Consultation response on Transport for London plans for a new East-West Cycle Superhighway**1. Introduction**

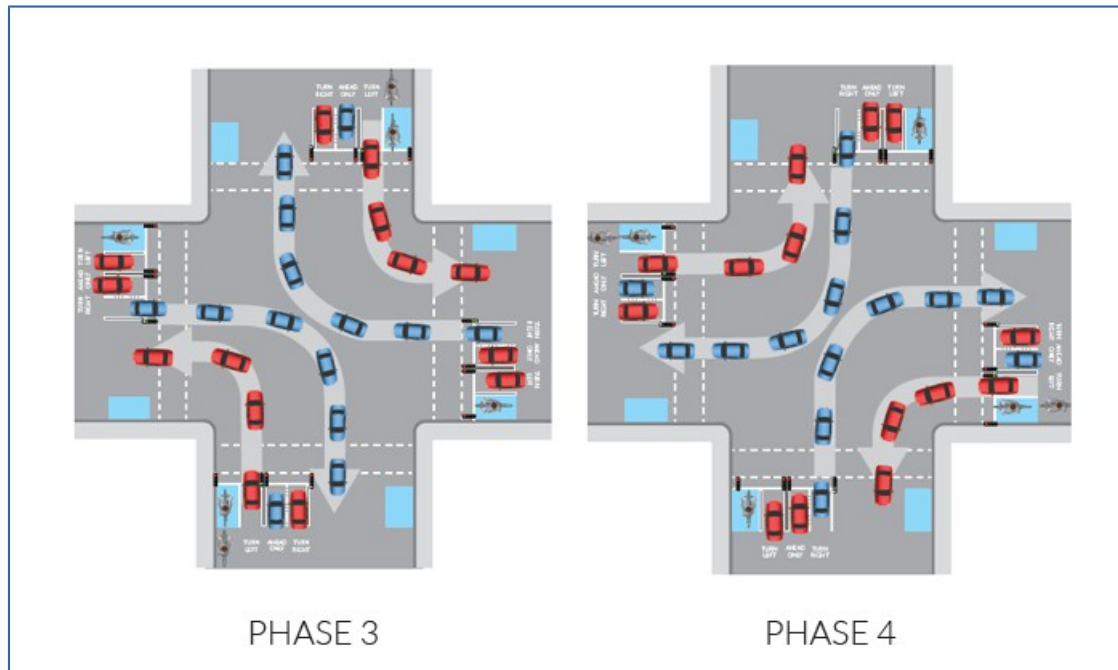
London Cycling Campaign has proposed a safe junction design for large signalised junctions which separates all turning movements from the straight ahead movements, for all traffic including pedestrians. This is shown schematically below for a four arm junction. We welcome the introduction of signal separated left turns for cyclists but it should be used more widely and on the access roads joining the route as well as along the route. It could be introduced at the junctions where there is a lot of road space such as at Tower Hill, Parliament Street etc. It can easily be adapted to large T-junctions such as Queen Street Place and also where the cross road is narrower and volumes are lower

Stage 1: In this diagram traffic lights are red for traffic turning left and right, and green for traffic – drivers, cyclists and pedestrians – going ahead.

East and west-bound traffic can go at the same time, and pedestrians can cross at the same time as the ahead traffic.

Stage 2: At the next phase, the North and south-bound traffic can go.

Result? No risk of traffic turning across the cyclists' path – therefore no left hook.

Stage 3: Next, the traffic lights go green for north and south bound left turns, and east and west bound right turns. All this traffic can go at the same time.

Stage 4: Now the other turns can be made. Further comments on each junction are included in the detailed route notes.

'Hold the Left' scheme for major T junction.

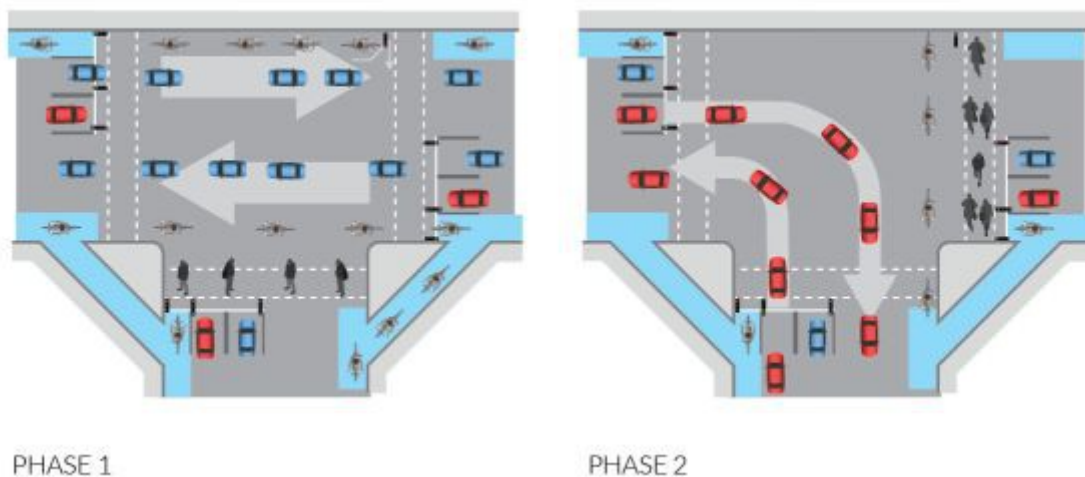
These sketches refer to a scheme with cycle tracks on all arms. For the two-track in the current consultation cyclists will have to make two stage left turns for some manoeuvres.

During Stage 1, all straight ahead east and west bound traffic - vehicles, cycles and pedestrians - can go. Turning motor traffic is held; cyclists turning right do the first stage of a two stage right turn.

In Stage 2, right turning southbound traffic can go - cycles making the second stage of their two stage right turn.

During Stage 3, left turning southbound motor traffic, right turning eastbound traffic (including cycles), and cycles turning left to go west can all go at the same time.

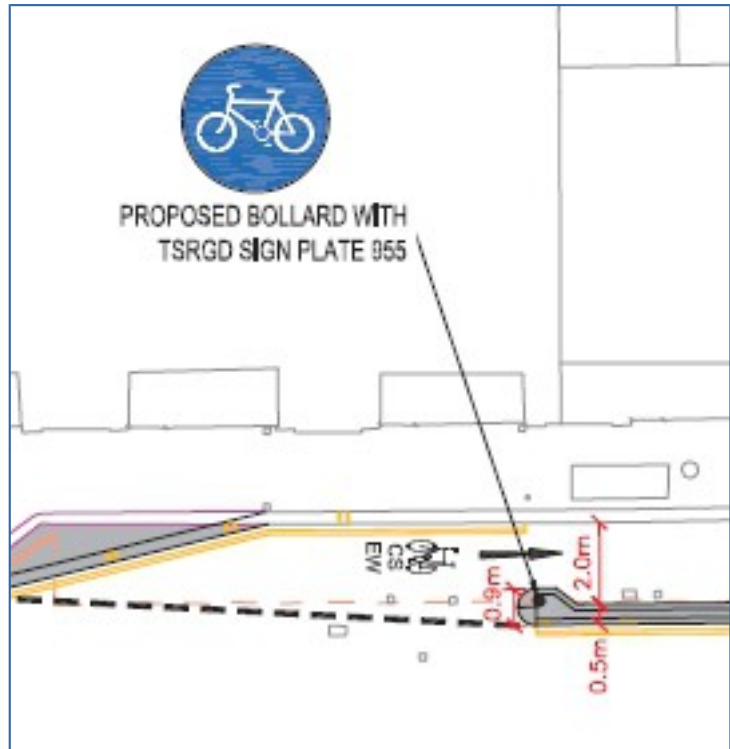
The use of an 'Early Start' junction design on Bayswater Road is unacceptable where there is a high demand for motor traffic including buses to turn left into Lancaster Terrace. The restoration of two way traffic on Bayswater Road is very welcome however there needs to be a protected route for cyclists using Bayswater Road to eliminate the risk of left turn collisions for eastbound cyclists at Lancaster Terrace and Stanhope Terrace.

Options 1 and 2 are between Bathurst St and Stanhope Terrace. If the latter the track width would go down to 1.5m which is unacceptable and it over complicates the Westbourne St/Stanhope Terrace junction. The northbound track width should be maintained at 2 metres as an absolute minimum. For either option there needs to be clear priority for cyclists (and equestrians) over motor traffic at the Sussex Square / Stanhope Terrace junction.

On Westbourne Street southbound there is one of the many unnecessary width restrictions to 1.6 metres to place a bollard on the separating island. This creates a real hazard blocking cyclists where they are most vulnerable to motor traffic. The bollard should be omitted as on the Stratford High

Street Superhighway and many other cycle routes in London. It could be replaced by a wand without increasing the width of the island.
